MODS. TO AMPLIFIER AC30/6
DRG. NO. A/026

OPTIONAL BRILLIANCE UNIT
AND CONNECTIONS TO AC30/6
(CIRCUIT)

CHECKED	SIG.	DATE
DRG N ^o . OS/010	OS	010

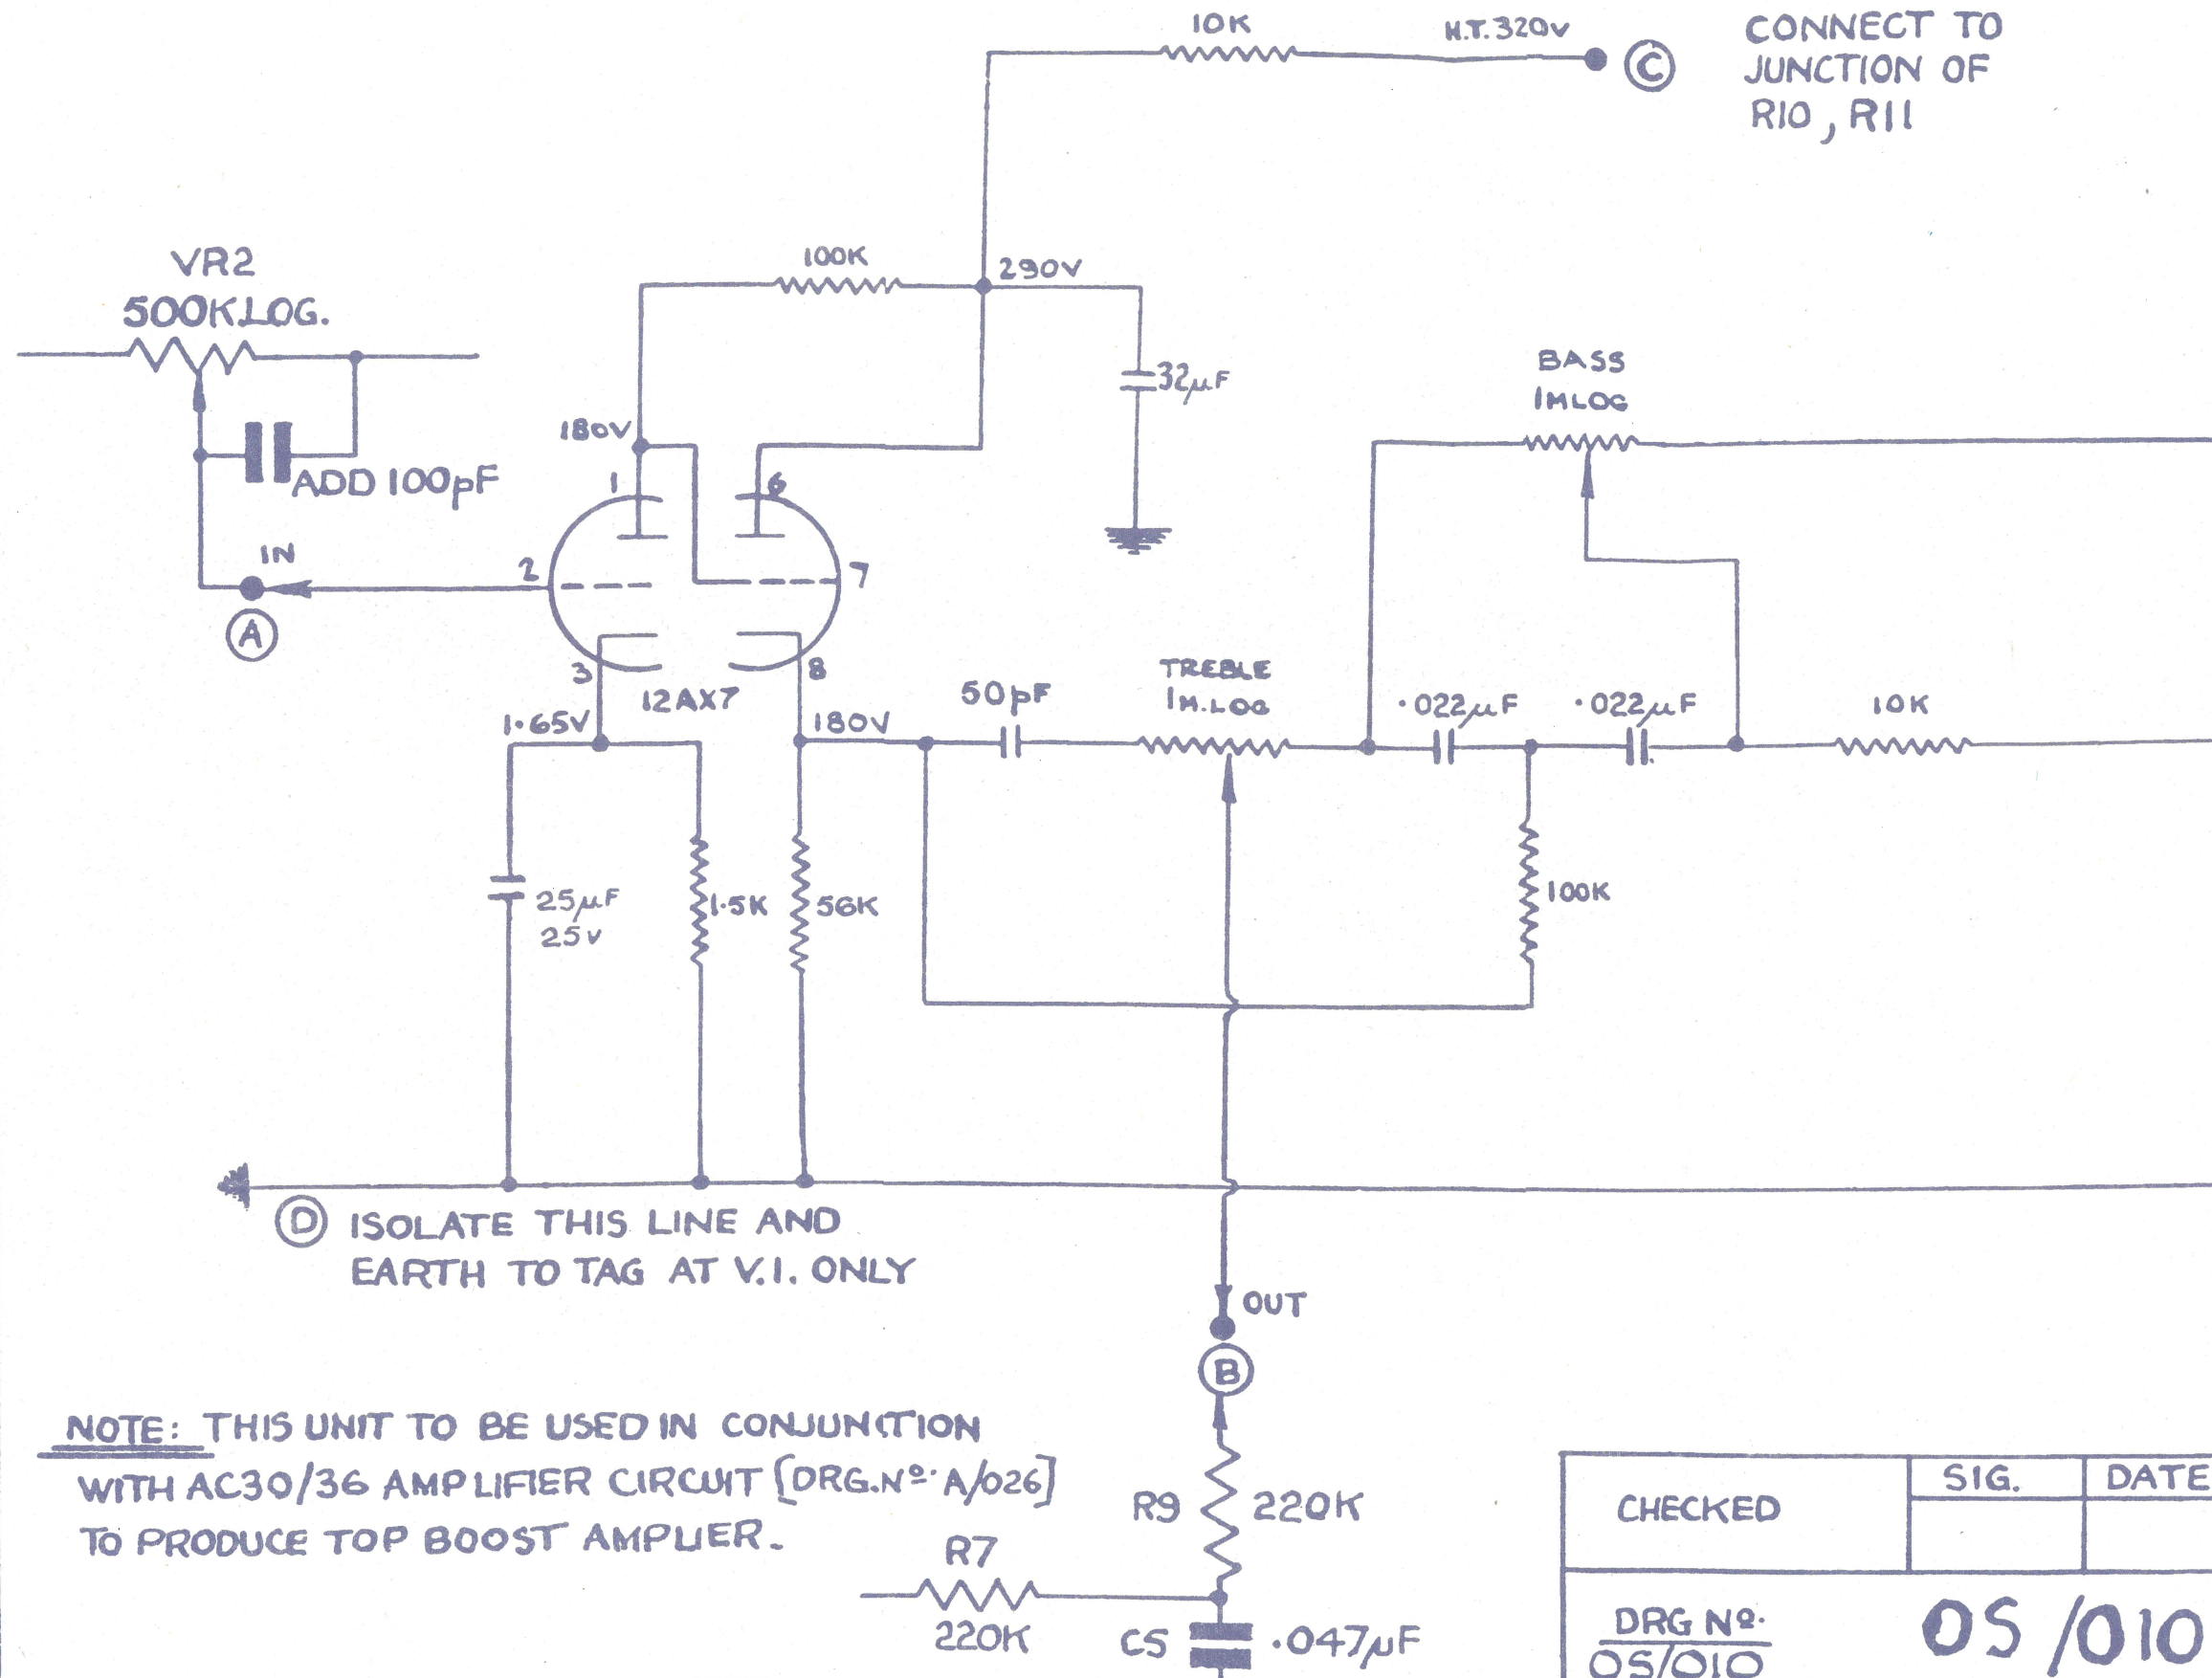
CONNECT HEATERS TO V.2.

3	15.2.65	
VOLTAGES & PIN NOS ADDED	2	14.6.63	
NOTE ADDED .022μF CAP. WAS .03μF VALUE.	1	11.2.61	
CHANGES	ISSUE	DATE	APP ^d
